1968 Corvette: Service Bulletin: Choke and Hot Restart Problems

Source: Chevrolet Dealer Service Technical Service Bulletin

Bulletin No: 68-T-23 Re-Issue

Date: Apr. 24, 1968

FIGURE 1

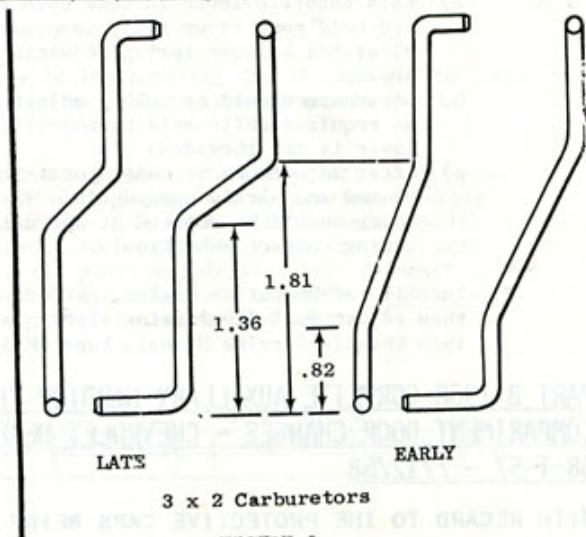
427 Cu. In. 390 H.P. Engine

Install new choke rod (Part No. 3937738) which has a greater off-set and a reverse entry direction at the choke lever end. Adjust to one rod diameter interference by bending at the off-set as necessary.

FIGURE 2

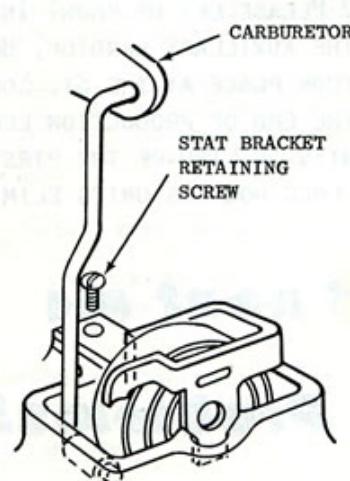
427 Cu. In. - 3 x 2 Carburetor Engines

Install new choke rod (Part No. 3919899) which has a greater off-set leg length and check for interference between choke thermostat coil and the manifold pocket as shown in Figure 3. If interference exists in this area, adjust the coil as much as possible on its mounting location, and if necessary, grind the pocket area or the choke rod end to gain clearance needed.
